# Memorandum

<b>Date:</b> January 23, 2026	
<b>To:</b> Gina Paolini	<b>Organization:</b> City of Capitola
<b>From:</b> RRM Design Group	<b>Title:</b> Design Review Team
<b>Project Name:</b> Capitola On-Call Architectural and Landscape Review	<b>Project Number:</b> 1783-11-PP25
<b>Topic:</b> 1475 41 <sup>st</sup> Ave Design Review Memorandum

We have reviewed the proposed design for compliance with Section 17.120.070 – Design Review Criteria, found within the City of Capitola Municipal Code.

*Front North Elevation*

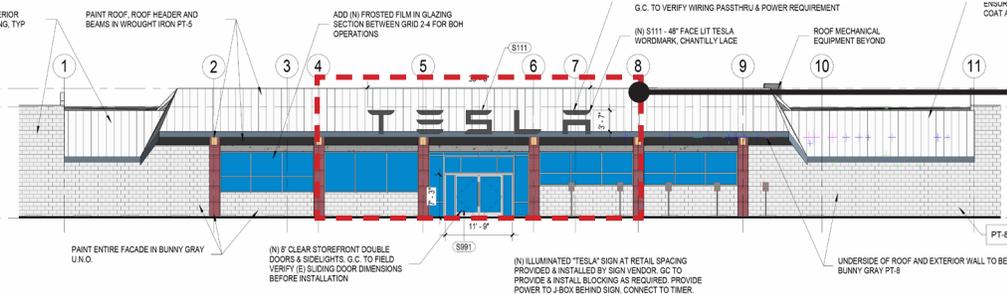
Building massing involves the size, shape, and visual presence of a structure and is a fundamental aspect of architectural design. Minimal changes to the building massing are proposed as part of the project, including the more prominent commercial storefront at the north elevation. The applicant should look for opportunities to incorporate entry elements to further enhance the overall commercial shopping center through further exterior renovations, particularly along the north elevation (CMC 17.120.070 H). This could include an emphasized primary entry or other pedestrian focused design interventions. Successful examples available for the applicant to use as inspiration can be found locally on the adjacent recently renovated New Leaf Market.

Explore existing Tesla dealerships and the adjacent New Leaf Market for entryway inspiration.

As shown on the Exterior Elevations on Sheet A4.02, the applicant intends to maintain the existing commercial storefront appearance and exclusively add a large, illuminated sign. The minimal design enhancements proposed does not enhance the visual interest and engagement with the public realm and the applicant should look for opportunities to further enhance the project design by improving the entryway. This could include the introduction of additional colors or materials, paneling system, roof changes, creating more of a commercial storefront presence, applying stylistically consistent canopies or awnings over entries, enhanced front door, and/or any design intervention that would assist in proposing a more engaging commercial storefront appearance (CMC 17.120.070 J).

- 3. Incorporate additional architectural detailing on the front north elevation through introduction of additional colors or materials, creating more of a commercial storefront presence, and/or any design intervention that would assist in proposing a more engaging commercial storefront appearance (CMC 17.120.070 J).

*Front North Elevation*

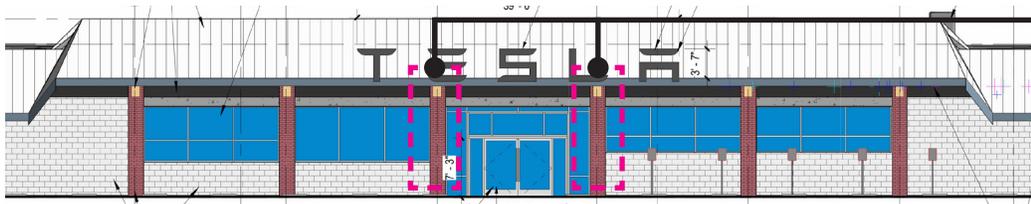
Primary entries contribute to the overall identity of buildings by defining architectural style and providing pedestrian connectivity. As currently designed, the primary entry lacks clear definition, visual interest, and general alignment with Tesla branding. The applicant should look for opportunities to further define the primary entrance by incorporating additional colors and materials to the entry to differentiate from the remainder of the storefront.

Alter colors and materials on columns adjacent to primary entry to emphasize entrance point to pedestrians and improve overall visual interest of the commercial storefront.

Windows and doors help define architectural style and add to the visual interest of a development. The applicant is not proposing any changes to the current window and door schedule found on the existing commercial storefront. However, the applicant should look for opportunities to modify the current storefront window application to create a more engaging storefront. Potential design interventions to accomplish this could be replacing the existing windows. Lastly, the applicant should explore applying a color such as the accent red to the proposed roll-up doors shown on the South Exterior Elevations on Sheet A4.01.

Look at enhancing entry. Also could expand existing storefront windows to the ground level to enhance visual appearance of the overall primary entry and establish a sense of transparency.

- 4. Further define the primary entrance by incorporating additional colors and materials to the entry to differentiate from the remainder of the storefront.

- 5. Modify the current window and door schedule to improve entry to enhance the visual appearance of the commercial storefront and better showcase internal Tesla showrooms.
